# Access Compliance Report

## Public Rights-of-Way

### (Curb Ramps)

Intersection ID: 52996	Main Street: TIMBERBROOK_DR	Cross Street: VICTORIA_BROOK_LN	Location: NE
ADA ID: 3154AAFB58B8	Ramp Type: PerpDiag	Initial Pass/Fail: Fail	Overall Compliance: No
Severity Score: 8.75			
Codes/Mitigation Info/Possible Solution		Field Measurements/Component Compliance

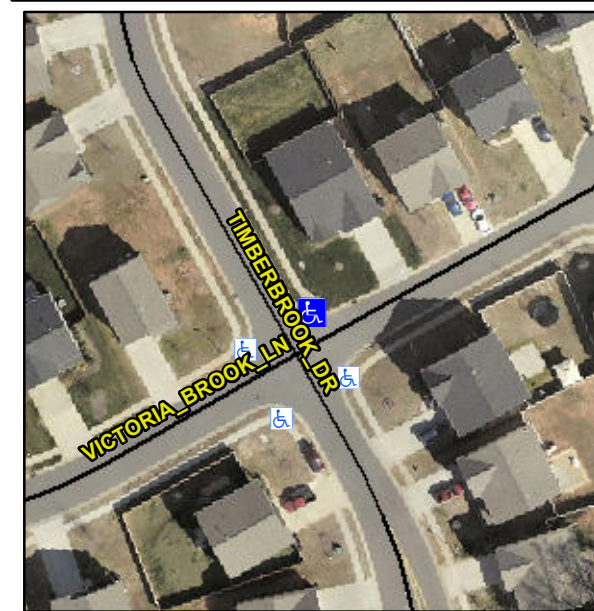
**Not Found, R304.5.1**

Compliance	Description	Data	Compliance	Description	Data
N/A	Ramp Length (in)	48.5	Yes	Ramp Slope (%)	6.6
No	Ramp Width (in)	47.0	Yes	Ramp XSlope (%)	1.7
N/A	Flare Type LT	N/A	N/A	Flare Type RT	N/A
N/A	Flare Slope LT (%)	N/A	N/A	Flare Slope RT (%)	N/A
N/A	Flare Traversable LT?	N/A	N/A	Flare Traversable RT?	N/A
N/A	Landing Length (in)	N/A	N/A	DWS Provided?	N/A
N/A	Landing Width (in)	N/A	N/A	DWS Contrast?	N/A
N/A	Landing Slope (%)	N/A	N/A	DWS Length (in)	N/A
N/A	Landing X Slope (%)	N/A	N/A	DWS Full Width?	N/A
N/A	Landing Curb? (Y/N)	N/A	N/A	DWS Offset (in)	N/A
N/A	Shared Landing?	N/A			
N/A	Gutter Ponding?	Yes	N/A	Gutter Slope (%)	N/A
N/A	Gutter Lip Ht (in)	N/A	N/A	Gutter X Slope (%)	N/A
N/A	Painted X Walk1?	No	N/A	Painted X Walk2?	No
	X Walk 1 Direction	To W		X Walk 2 Direction	To S
N/A	X Walk 1 Width (in)	N/A	N/A	X Walk 2 Width (in)	N/A
	X Walk 1 Slope (%)	1.4		X Walk 2 Slope (%)	1.7
	X Walk 1 X Slope (%)	0.9		X Walk 2 X Slope (%)	1.9

**Remove & Replace Curb Ramp With Two New Directional Ramps or Equivalent.**
